Replacing JH Pods with KH Pods

NOTICE
Revised August 2016. This bulletin supersedes the previous bulletin number 2012-66R2 June 2014.

Models Affected

Models Covered	Serial Number Or Year
Zeus 3000 series pods	0M963373–0M968996

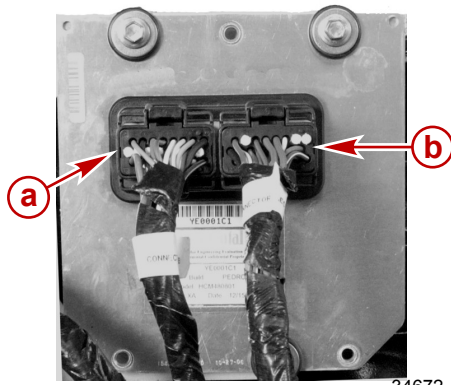
When a vessel has SC2.5 software in either the port or starboard pod and SC2.2 software in the opposite pod, CDS G3 can be connected to that vessel to check compatibility of the TVMs. The module data screen will show the Calibration ID levels. Cal ID's of the TVMs will differ as shown in the following example.

Notice the initial portion of the Cal ID of the STBD TVM is TVM12ZXXXPAAA. The port is TVM09ZXXXPABA. This indicates that the TVM module on the starboard side contains SC2.5 software and the port side TVM module contains SC2.2 software. The TVM version may vary slightly from this software version.

To align the vessel with tested and approved architecture, when you have one SC2.2 JH pod and one SC2.5 KH pod, you must replace the TVM on the SC2.2 JH pod with a TVM that contains SC2.5 software. Follow the direction below to replace the TVM.

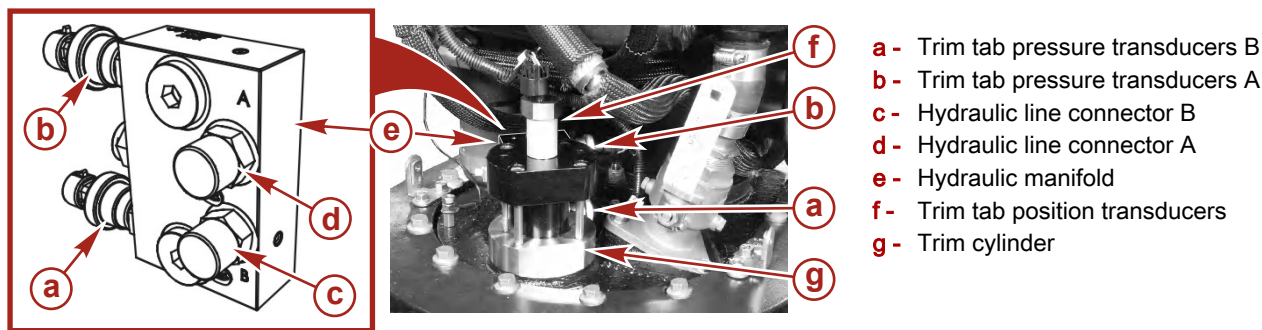
Each pod's hydraulic steering manifold contains three pressure transducers. These steering pressure transducers are indicated by letters b, c, and e in the following illustration.

Each pod's hydraulic trim tab manifold contains two pressure transducers. These trim tab pressure transducers are identified by the letters a and b in the following illustration.

The kit for the transducer replacements includes the five transducers and two labels to apply to the steering and trim manifolds to indicate that the transducers have been replaced with the higher scale transducer.

Label Placement

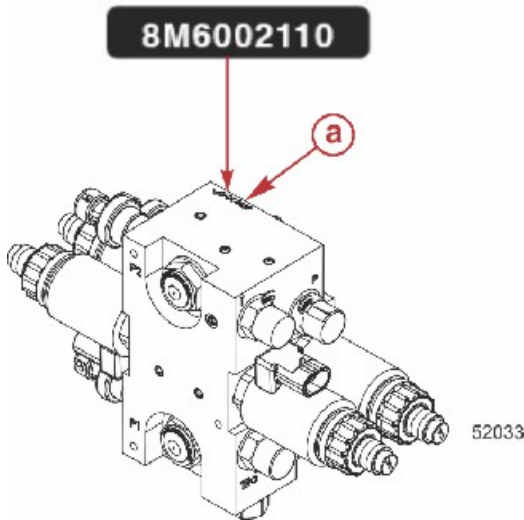
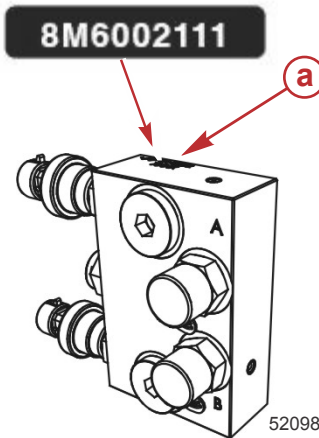
Two decal labels are included in the transducer kit. The labels should be installed on the steering manifold and the trim manifold. Use the following illustrations to determine the placement of each label. These labels indicate that the newer 3500 psi pressure transducers have been installed for future part replacement reference. Ensure that the surface is clean, dry, and free of oil prior to the application of the decal.

Steering manifold
a - Affix the decal here
